PRELIMINARY 10012 CAPITOL VIEW AVE

# MONTGOMERY COUNTY HISTORIC PRESERVATION COMMISSION STAFF REPORT

PROPOSAL:

Construction of additions and porches

PROPOSED REAR ELEVATION

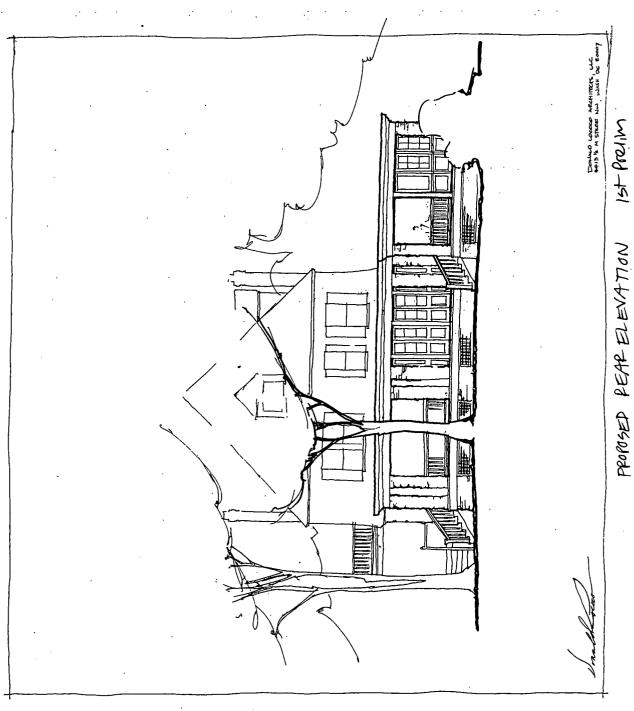
• Simplify the massing and treatment—integrate the massings better so they aren't 3 separate pieces Reduce or remove left side open porch

There was a fair amount of discussion about the floor plans since some of the new rooms didn't have doors and the upstairs room was labeled sleeping porch and the sun room was labeled screen porch, but we tried to keep the discussion to the overall proposal and massings.

EXISTING / DEMO FRONT BLEVATION
SCALE 1/4"- 1'0"

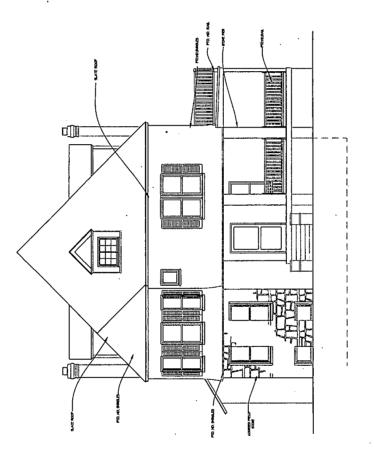
And that it is a sizeable addition in footprint with the porches, and that that should be reduced so it is not quite such an impact to the house. There was on the left side, the plans shows the removal of a window at the front left to create a door opening to a terrace, and staff would recommend that that change not occur. That that original window should remain and that opening should remain the size that it is.

While generally staff would not recommend the replacement of the left side front window with a door to access the terrace since an overall preservation goal is the retention of as many original features and openings as possible, the Commission did not seem opposed to the change and the applicant has evidence that the existing opening is not the original opening and this area has previously been altered. There will be a door off the addition to the terrace so the second door may not be necessary.
